7.7 Control Systems Not Required for Safety

The information in this section of the reference ABWR DCD, including all subsections and figures, as modified by the STP Nuclear Operating Company Application to Amend the Design Certification rule for the U.S. Advanced Boiling Water Reactor (ABWR), "ABWR STP Aircraft Impact Assessment (AIA) Amendment Revision 3," dated September 23, 2010 is incorporated by reference with the following departures and supplements.

Figure 7.7-11 Simplified Functional Diagram of the Automatic Power Regulation System

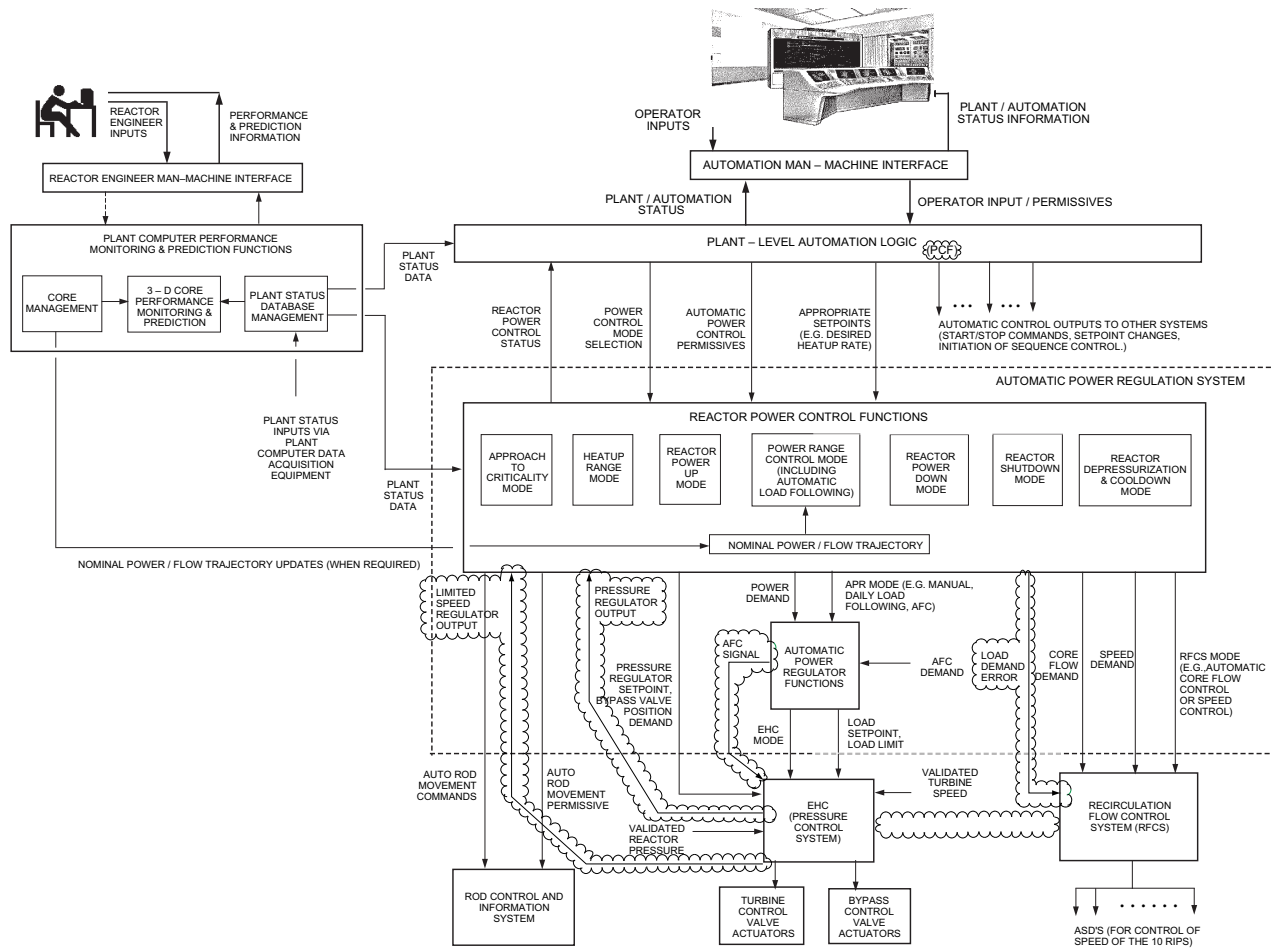
STD DEP T1 3.4-1 (Figures 7.7-2, 7.7-3, 7.7-4, 7.7-5, 7.7-7, 7.7-8, 7.7-9, 7.7-11)

STD DEP 7.7-20 (Figures 7.7-5, 7.7-7, 7.7-11)

STD DEP 7.7-24 (Figures 7.7-11, 7.7-12, 7.7-13)
